BULLETIN # 0 5

PROJECT: Harrison Recreation & Community Center – PHASE 1
Harrison, NY

RE: Revised Retaining Wall Elevations- Reference C-100

Sheet No.
ASK - 4

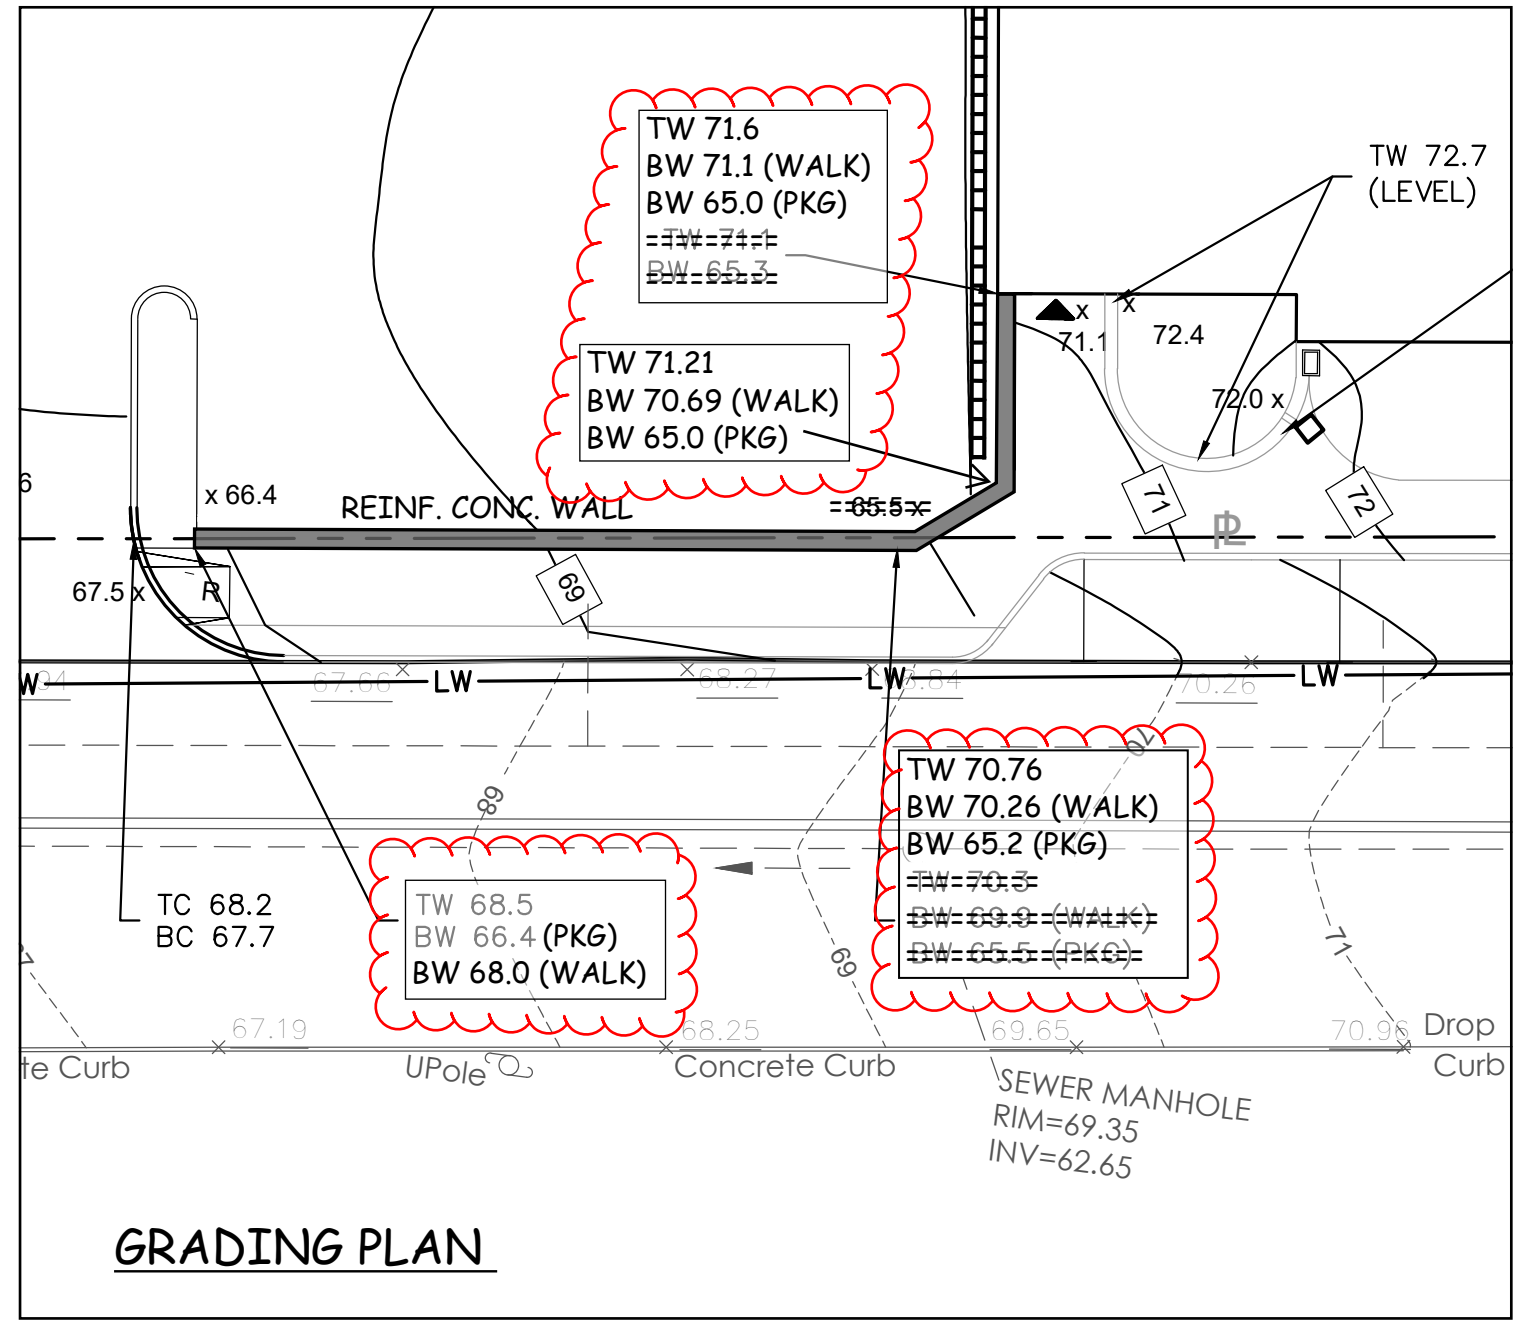
Additional top and bottom of wall height elevations for the sidewalk side and the parking lot side of the south side concrete retaining wall.
